RHODES BUSINESS PARK

TECHNICAL NOTE

Flood Zone Analysis Modelling Results

Document No: 40055-BGL-XX-XX-TN-C-00006

Figure 3-2: Baseline 100-year flood extent with climate change

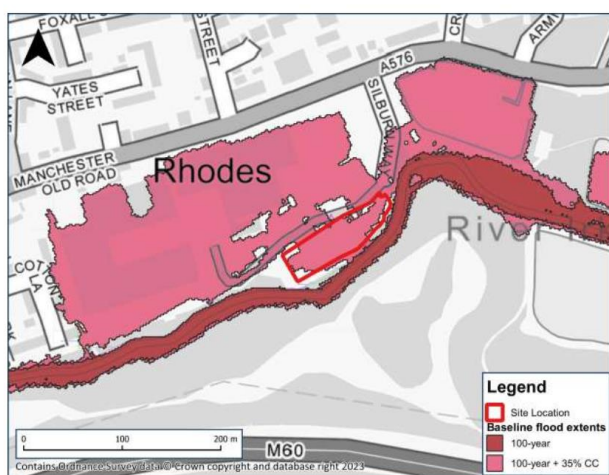
EA Comment: 23 May 2024

Flood Mitigation and Storm Events

The site is not prone to flooding for the 100 year storm event.

The site is at risk of flooding for the 100 year +35% climate change storm event. The predicted flood depths are generally less than 100mm across the site.

Figures 3-2 and 3-3 from the JBA report are reproduced below for reference showing the predicted flood extents and levels for the base line scenario (pre-development):

From Figure 3-2, above, and satellite image, below, the flood area extent reaches the existing industrial site and the park pond/basin to the northeast measuring ~42,500m² in plan area. The industrial estate is part of the development site which is owned by the applicant

As can be seen in the JBS report figure 3-2, the primary overland flood routing is along Silburn Way through the industrial estate and rejoins the River Irk to the west of the property. The levels on Silburn Way drop from north to south into the industrial estate and then level out with the lowest levels in the estate at the western boundary along the river where the flow path rejoins the river.
